**BC BUILDING CODE INTERPRETATION COMMITTEE**  
**AIBC, APEGBC, BOABC, POABC**

**File No: 98-0081**

Subject: Handrails for Platform/Stage Stairs

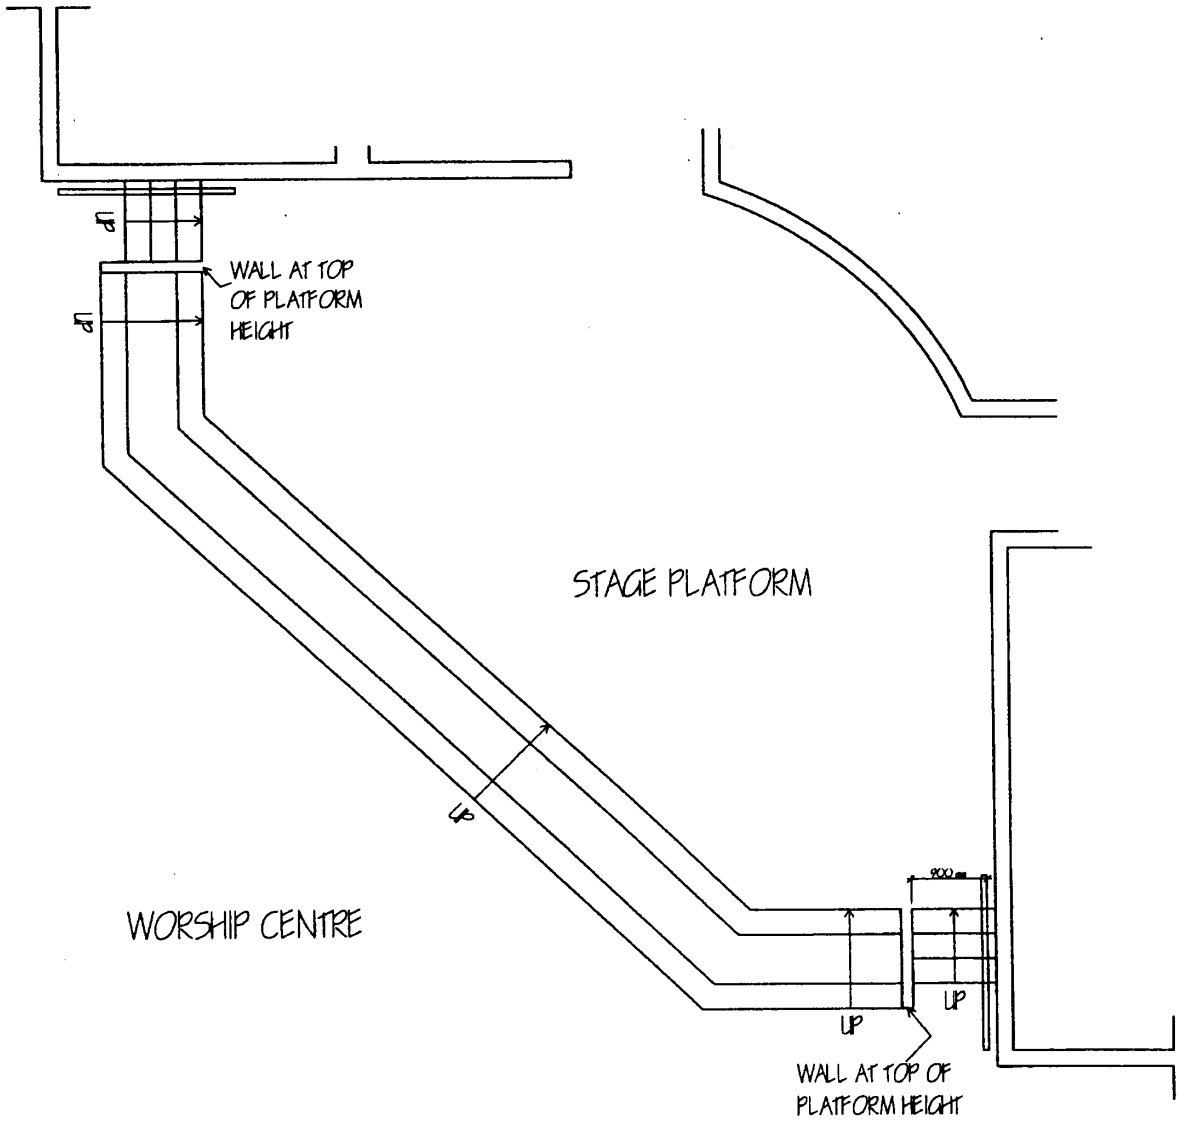
A raised platform (approximately 600mm [2 ft.] above floor level) is used as a stage in a church building. The platform has an area of approximately 50 m<sup>2</sup> with an occupant load of up to 70 persons. Two stairs with four risers are provided, one at each side of the platform. The front edge of the platform (stage) is provided with steps--with no handrail. Are handrails required for the steps at the front edge of the platform/stage?

Note the steps at the front edge of the platform/stage are not part of the required means of egress for the platform/stage.

No.

Sentence 3.3.1.17.(1) exempts the requirement for a guard at the front edge of a stage. A stepped front edge to a stage does not trigger the front edge to comply with the stair handrail requirements. The stairs at either end of the platform/stage are required to comply with the stair and handrail requirements. Sentence 3.3.1.13.(1) requires means of egress stairs to comply with the dimensional, guard and handrail requirements in Section 3.4. Based on the proposed size of the stage, the required width of each stair is 900 mm (Clause 3.4.3.1.(2)(b) and Article 3.4.3.4.). Sentence 3.4.6.4.(1) requires a handrail on at least one side of a stairway, and if the stair is 1100 mm or more in width, handrails are required on both sides. Sentence 3.4.6.4.(2) goes on to clarify that intermediate handrails must be installed, where the "required width" of a stair exceeds 2200mm. It is therefore interpreted that the required width of the means of egress stairs is 900 mm and each stair requires at least one (1) handrail conforming to Article 3.4.6.4.

Refer to the attached drawing for clarification.
